IEEE P802.11
Wireless LANs

Comments received on 802.11b in Letter Ballot 16

Date: January 9, 1999

Task Group b Editor

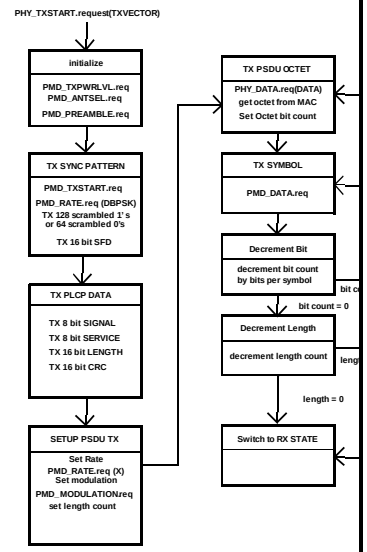
79.	1	1.2.5	ca	E	N	The figure 8 needs to be modified for the LONG/SHORT PREAMBLE

ACCEPTED: editor to make changes
80.	3	1.2.2.3	Dk	E	N	Figure 3 is missing.	Add figure 3 back in.	Accepted, add in figure 3

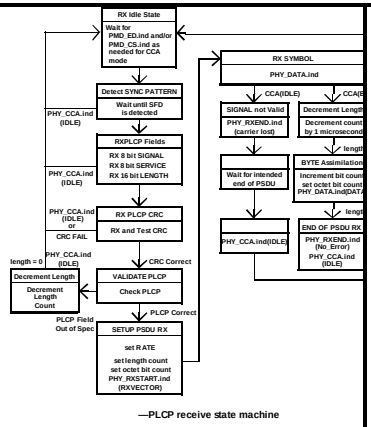
95.	2	1.2.6	ca	E	N	The Receive state machine needs to have the set RATE mechanism modified
